# 153 CORNFoot ST

Consent number: 4/1965

**1st Request for further information on Application.**

Project Number: BC04/1965  
Project Location: 153 Cornfoot St WANGANUI 5001  
Project Description: New garage & construction of a carport attached to dwelling & lounge extension.

plan as altered ~~to~~ N.T.S.

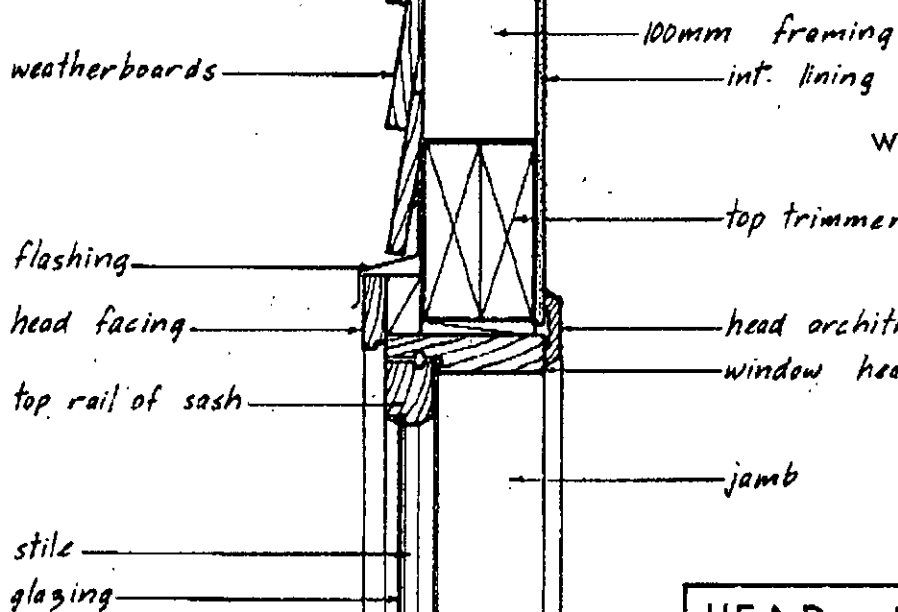
1. Please supply construction details for the window/door head, jamb and sill flashings. (Graham Wait - Building Control Officer)
2. Please show on the floor plan the position of the smoke alarms in accordance with F7 of the New Zealand Building Code. (Graham Wait - Building Control Officer)

3. Please supply a truss design and layout plan. (Graham Wait - Building Control Officer)
4. The 100x100 posts cannot be installed to carry a 2kpa floor loading, NZS 3604 SECTION 9.1 and SECTION 6.4.2. Please amend the plans. (Graham Wait - Building Control Officer)

- THE REQUESTED WINDOWS DETAILS, CHANGE TO POST SIZE & STORMWATER FOLLOW THIS.
- TRUSS LAYOUT & DESIGN TO BE SUPPLIED BY BUILDER, WHO HAS BEEN CONTACTED.
- BRACING CALC'S & PLAN FOR GARAGE AREA ARE AS FOLLOWS, HOUSE BRACING IS EXISTING.
- SMOKE ALARM POSITION SHOWN ON AMENDED PLAN.

sheds in this  
area to be  
90x75 H12 HSG8  
@ 4000/c, remaining  
sheds for garage  
to be @ 4000/c

\* = amended DEC. 04

**BRACING PLAN.**

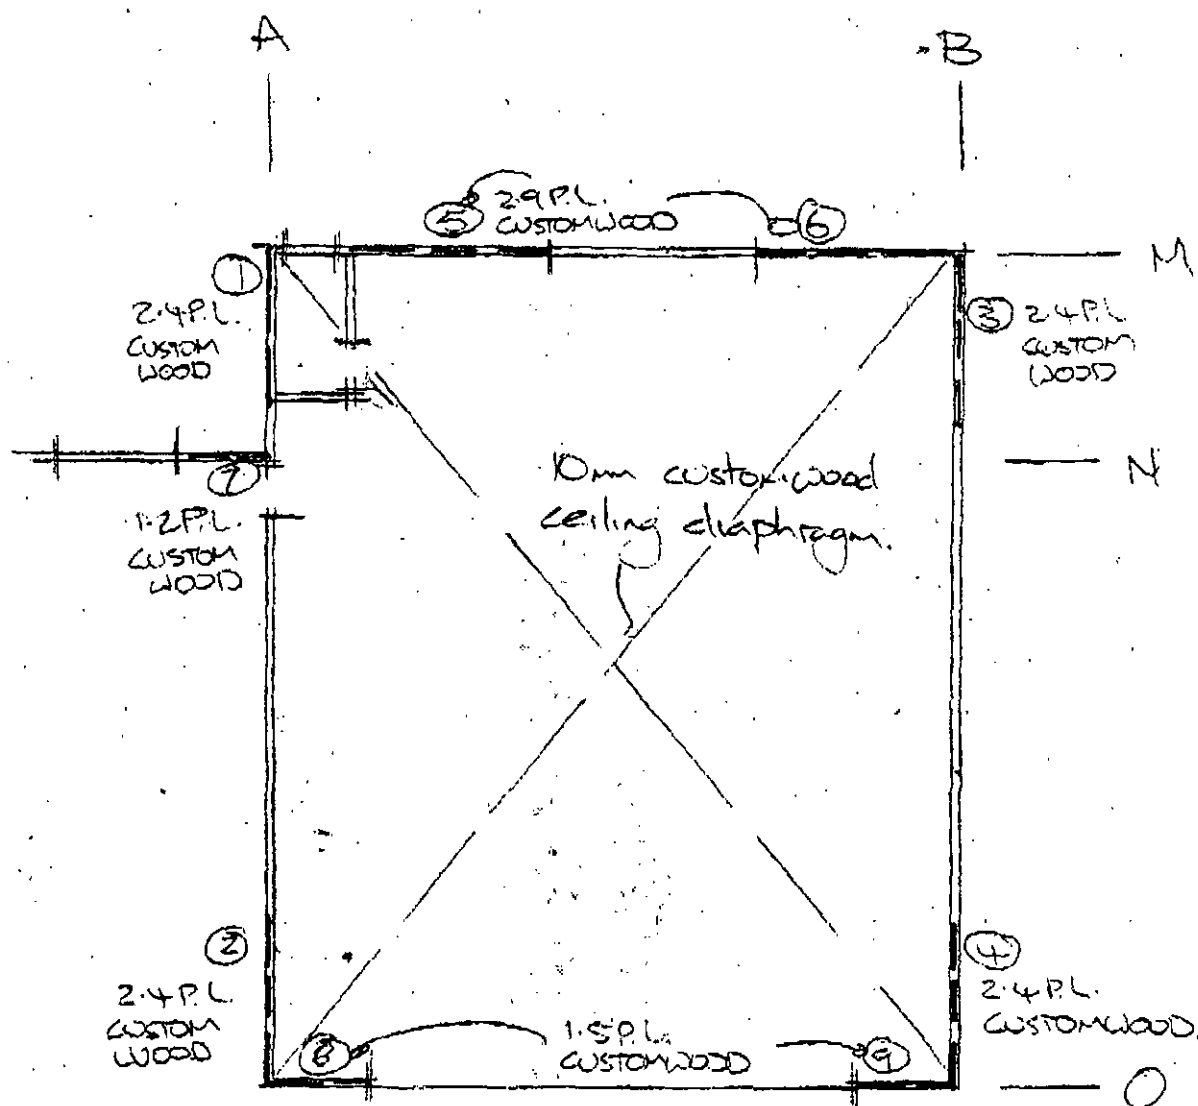
5. Customwood cannot be used as a bracing element as it cannot achieve 50 year durability, (see manufacturers installation instructions). Please supply wall bracing calculations and amend the plans. (Graham Wait - Building Control Officer)

P.L. = plan length  
BRACING TYPE = 10m custom wood to  
interior walls, wall 1.2m - 2.3m wide  
require 6kN straps, 24m up no  
straps required, sheets nailed @ 150mm
